ORIGINATION FORM

Proposed Revisions to a Standard Plans Index

Index Number: 455-440

Index Title: Precast Concrete Sheet Pile Wall
(CFRP/GFRP & HSSS/GFRP)

INDEX SHEET
 455-440 1 of 4

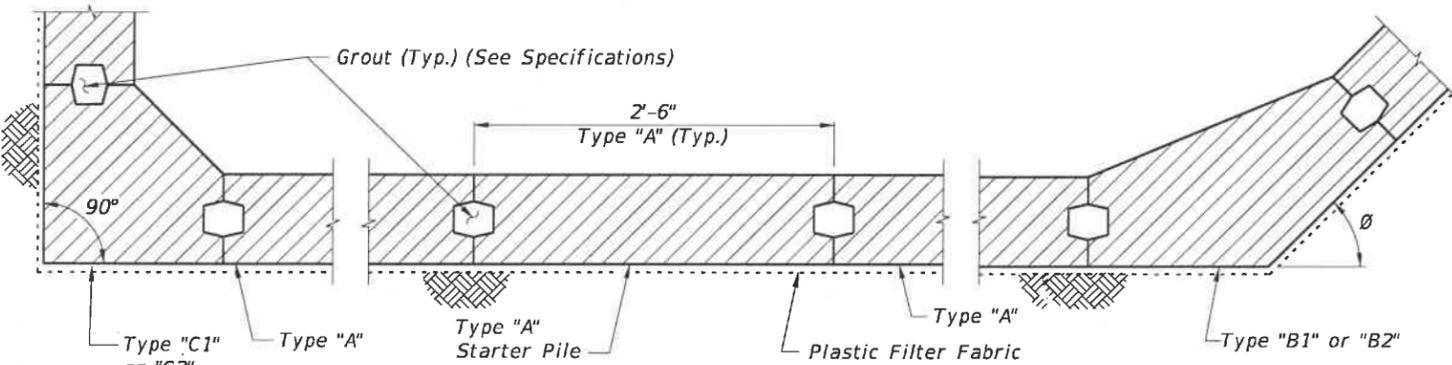
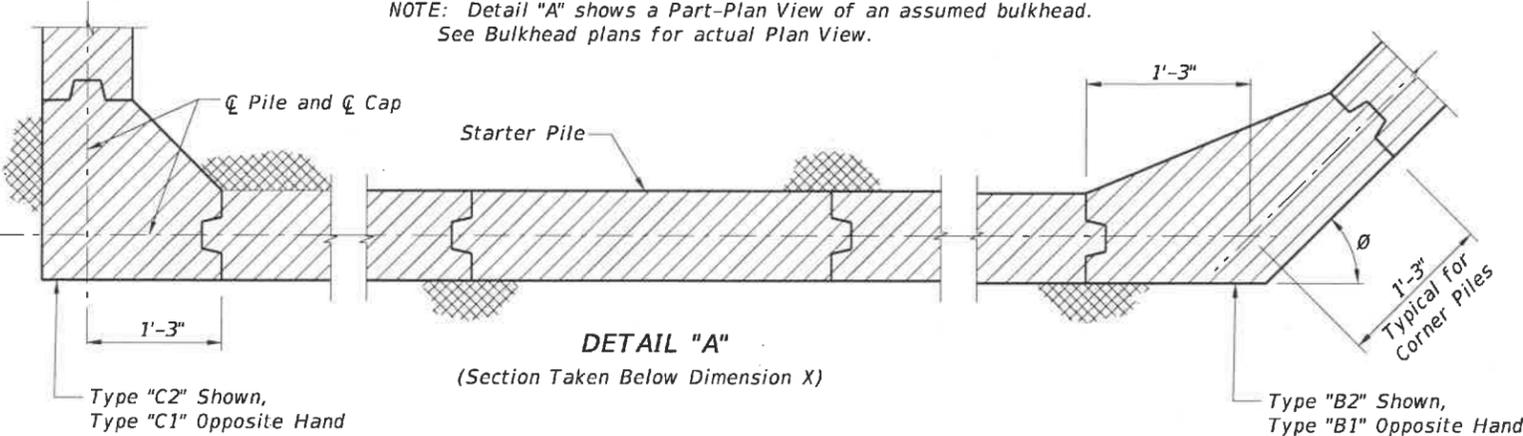
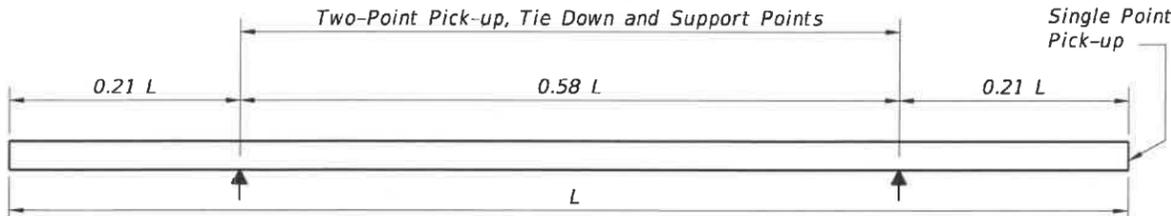
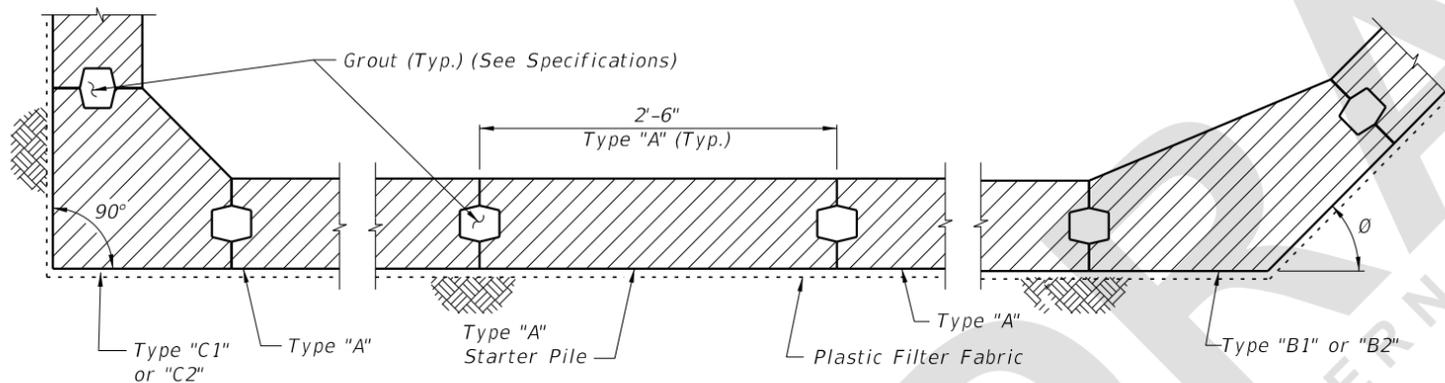
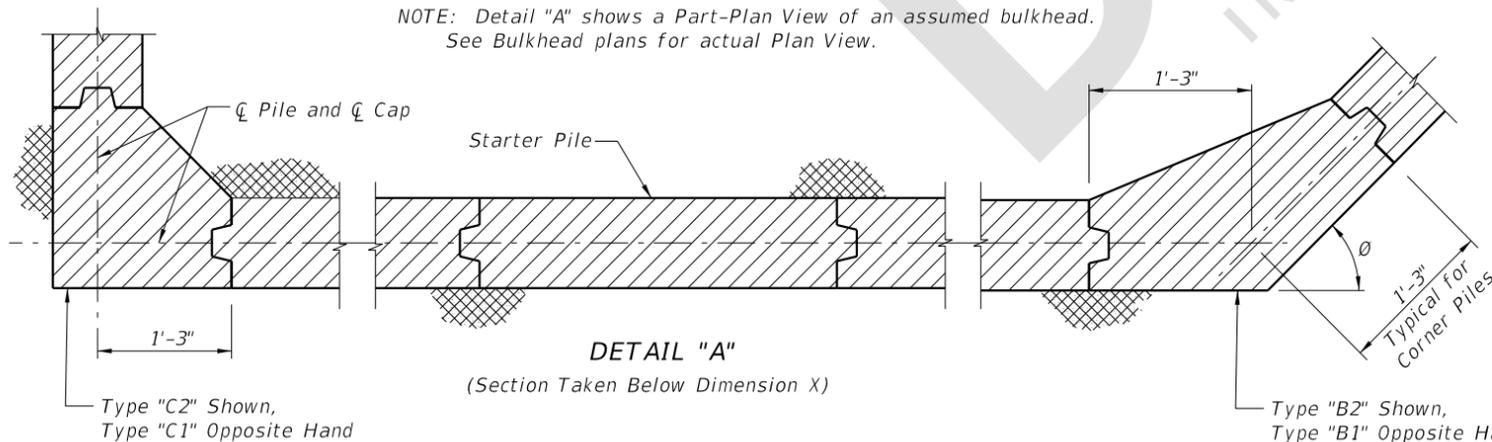
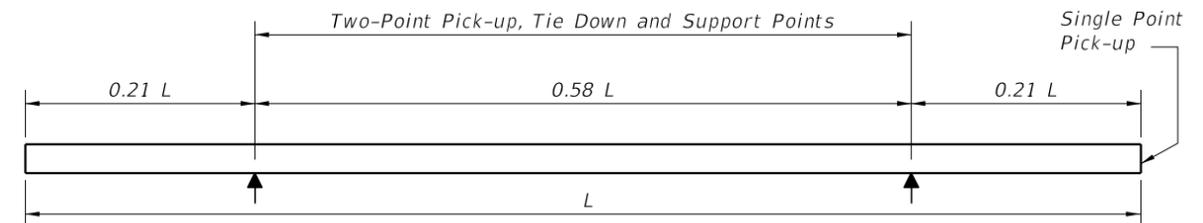
Summary of the changes:

Changed Class V (Special) concrete to Class V.

MATERIALS: (for materials not listed refer to the Specifications)
CONCRETE
 Class: V (Special)
 Unit weight: 145 pcf
 Modulus of Elasticity: Based on the use of Florida limerock aggregate concrete

Class: V
 Unit weight: 145 pcf
 Modulus of Elasticity: Based on the use of Florida limerock aggregate concrete
